WESTWOOD HILLS 2ND ADDITION

Re: S/D 98-57 -- One-Step Final Plat of WESTWOOD HILLS 2ND ADDITION

Re: S/D 98-57 -- One-Step Final Plat of WESTWOOD HILLS 2ND ADDITION

CASE NUMBER: S/D 98-57 - WESTWOOD HILLS 2ND ADDITION

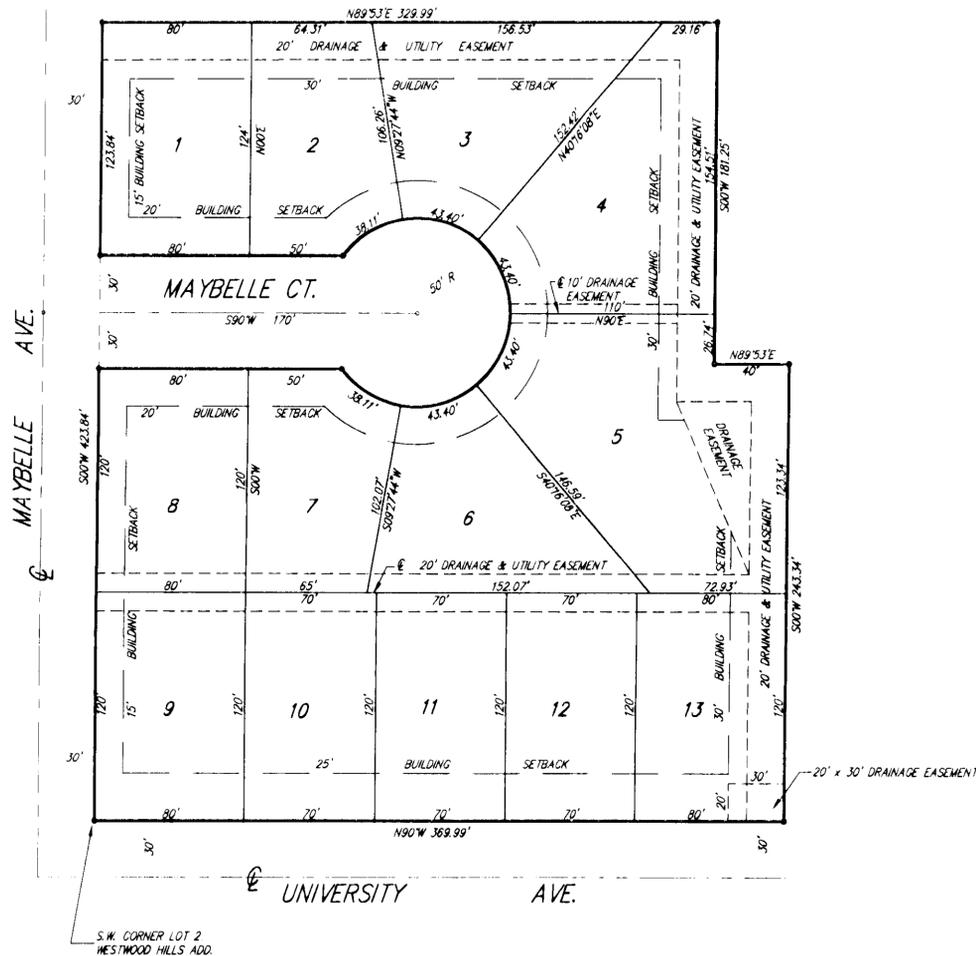
- A. City Engineering needs to indicate if any guarantees are required. Guarantees are required for the extension of water and sewer to serve the lots.

- C. City Engineering needs to comment on the status of the applicant's drainage plan. The drainage plan is approved. Drainage easement shall be denoted to cover the proposed storm sewer. A storm sewer guarantee will be required.

- D. The applicant shall guarantee the paving of the proposed interior street.
- E. The final plat tracing shall reference a tie point from a section corner and its distance to the plat.

- F. The perimeter of the plat does not coincide with the perimeter of Parcel 4 of the CUP and an administrative adjustment needs to be completed. In addition, the plat does not conform with the 50-foot setback imposed by the CUP along Maybelle and University Avenue (15-foot and 20-foot platted setback). MAPD recommends maintaining the standard 25-foot front yard setback along

- University Avenue. An administrative adjustment needs to be completed for this setback revision.
- G. **Traffic Engineering** needs to comment on the need for any improvements to University Avenue and Maybelle Avenue. **No improvements are needed.**

- N. Perimeter closure computations shall be submitted with the final plat tracing.
- O. Recording of the plat within thirty (30) days after approval by the City Council and/or County Commission.
- P. The representatives from the utility companies should be prepared to comment on the need for any additional utility easements to be platted on this property.
- Q. The applicant is reminded that a disk shall be submitted with the final plat tracing to the Planning Department detailing this plat. This will be used by the City and County GIS Department.
